Re: ADDENDUM NO. 1

City of Downs, Kansas
Water Treatment Plant Improvements
KDHE Project No. 2976
WCI File: 16-600-511-01/02/8670/8600

A1 WELL #8 - WELL HOUSE IMPROVEMENT PLAN & DETAILS
NOT TO SCALE

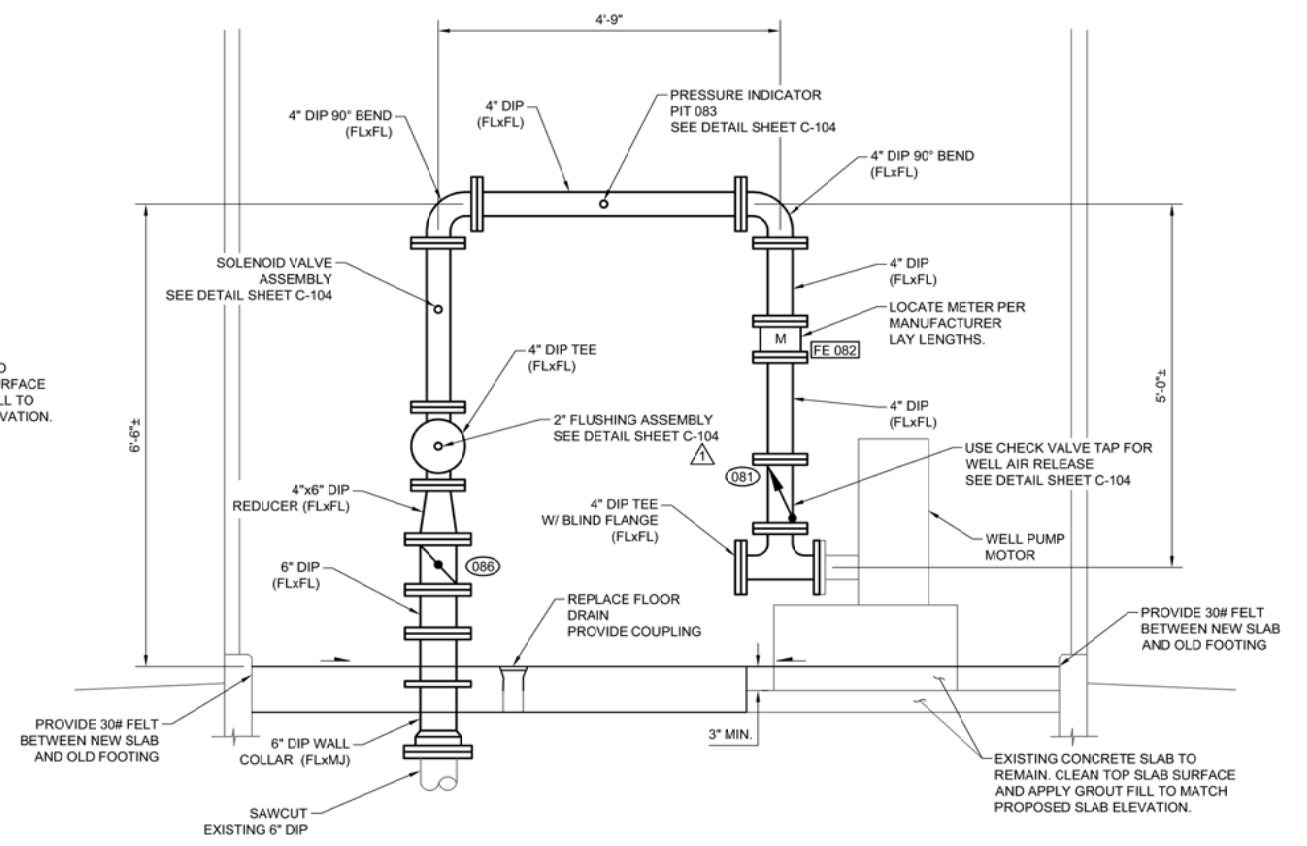
1. Sheet No. C-105, Well #8 – Well House Plan & Details:
Detail A1, CLARIFICATION regarding floor slab. See attached Detail A1 on Sheet C-105A1. Clarification is in regards to the extents of the complete slab replacement (hatched area).
2. Sheet No. C-105, Well #8 – Well House Plan & Details:
Detail A6, CLARIFICATION regarding floor slab. See attached Detail A6 on Sheet C-105A1. Clarification is in regards to the extents of the existing slab cleaning and grout placement. Grout fill shall be placed over entire floor where the new slab does not cover.
3. Sheet No. E-120, Water Treatment Plant – Power Plan:
ADD WP/GFI mounted at 42" AFF for FE1082. Receptacle shall be fed from circuit LA-34 with 2-#12, #12G. Coordinate location with meter installation.
4. Sheet No. E-601, One-Line Diagram:
ADD 20A Circuit breaker to LA-34.
